STAFF REVIEW AND RECOMMENDATIONS  
PUBLIC HEARING  
JUNE 24, 2020

PRELIMINARY PLAT: FULLER LAKE HEIGHTS RSB BLOCK 4, LOTS 13 & 14  
LEGAL DESCRIPTION: SEC 34, T18N, R02W, SEWARD MERIDIAN AK  
PETITIONERS: H & H CONSTRUCTION  
SURVEYOR: KEYSTONE SURVEYING  
ACRES: 4.39 ± PARCELS: 1  
REVIEWED BY: AMY OTTO-BUCHANAN CASE #: 2020-075

PRELIMINARY PLAT: RIDDELS' ORIGINAL RSB LOT 1  
LEGAL DESCRIPTION: SEC 34, T18N, R01W, SEWARD MERIDIAN AK  
PETITIONERS: NORTH LIT HOMES LLC  
SURVEYOR/ENGINEER: HANSON LAND SOLUTIONS  
ACRES: 4.4 ± PARCELS: 4  
REVIEWED BY: AMY OTTO-BUCHANAN CASE #: 2020-077

A PLAT OF  
**RIDDELS' ORIGINAL LOT 1 SUBDIVISION**  
A SUBDIVISION OF  
LOT 1  
**RIDDELS' ORIGINAL SUBDIVISION (66-12)**  
PALMER RECORDING DISTRICT  
STATE OF ALASKA  
LOCATED WITHIN  
SW 1/4 SEC. 34, T.18N. R.1W. SM, AK  
CONTAINING 4.40 ACRES MORE OR LESS

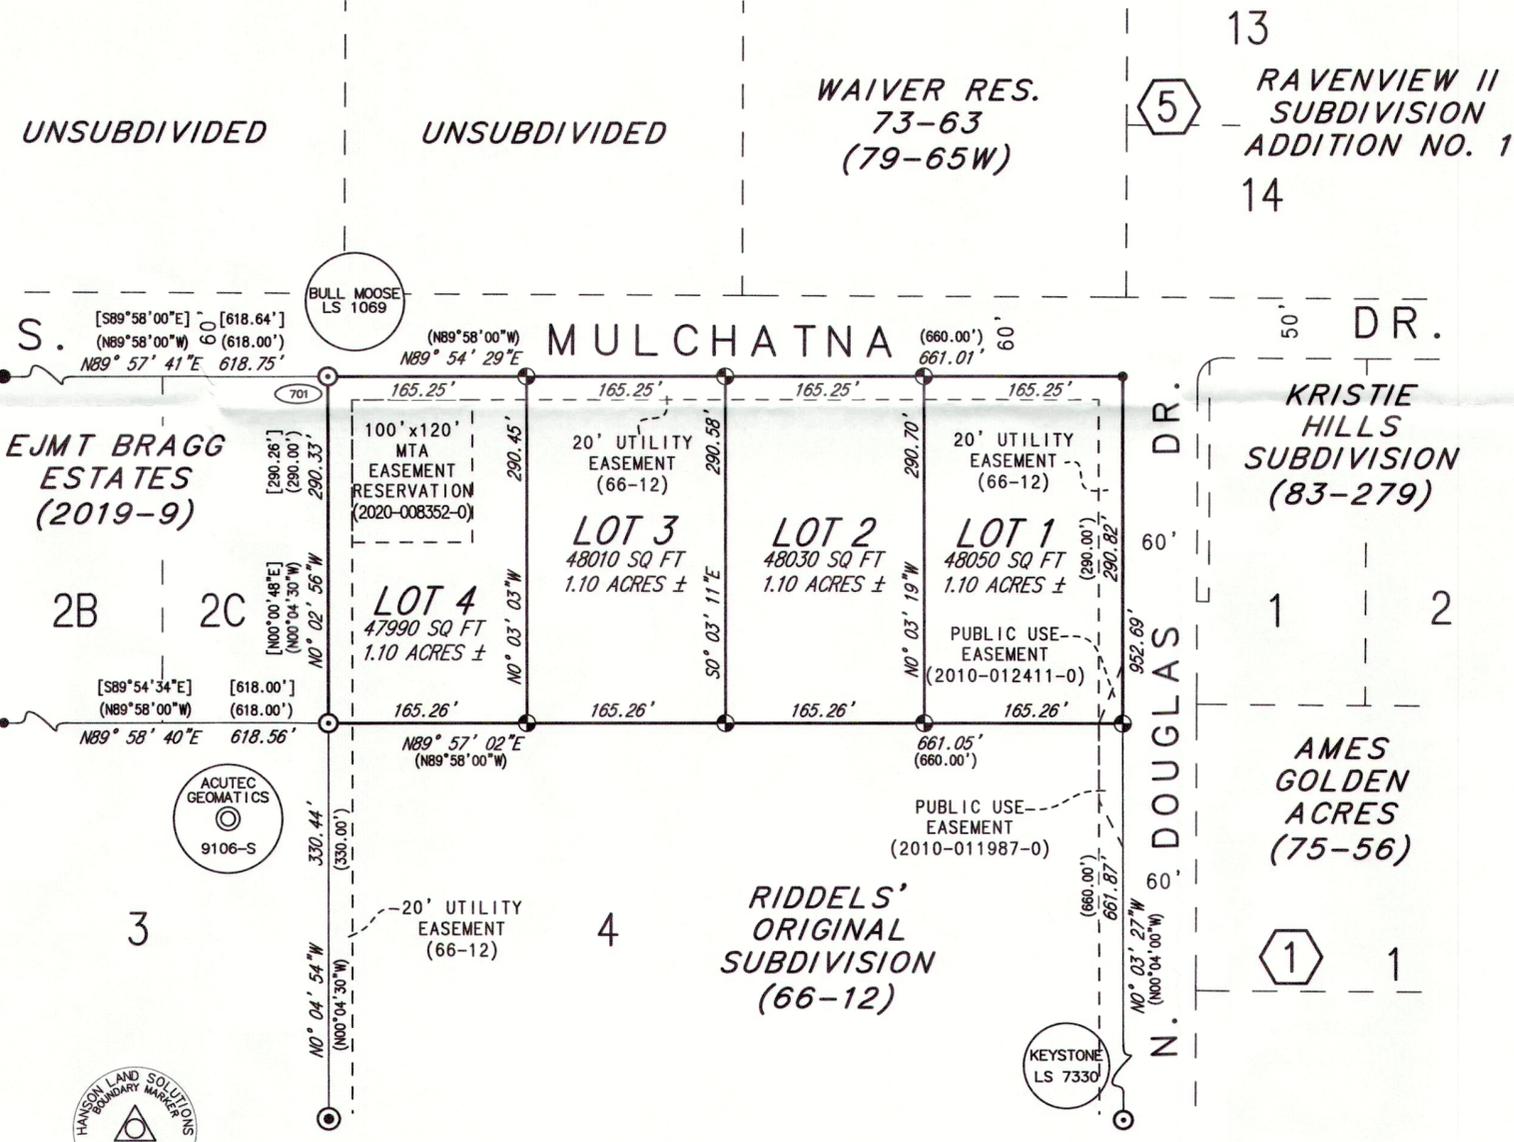
Mulchatna Drive is classified as a minor collector. According to SCM A06.1, Residential collector streets, a sub-classification of minor collector, should be designed to have no residential lots directly fronting on them. Please redesign to have as many lots as possible fronting on Douglas Drive, a residential street.

MEA comments to include easement in plat notes.

1. Taxes and special assessments must be paid in full for the year of recording, pursuant to MSB 43.15.053(F) and AS 40.15.020. Pay taxes and special assessments (LIDs), by CERTIFIED FUNDS OR CASH.
2. Provide updated Certificate to Plat executed within seven (7) days of recording of plat and submit Beneficiary Affidavit for any holders of a beneficial interest.
3. Provide signatory authority documentation for North Lit Homes, LLC.
4. Pay postage and advertising fees.
5. Show all easements of record on final plat.
6. Provide a plat note to read: Lot 1A to take access from N. Douglas Drive only. Lots 1B & 1C shall share a common access point at the common lot line.
7. Submit recording fees, payable to Department of Natural Resources (DNR).
8. Submit final plat in full compliance with Title 43.
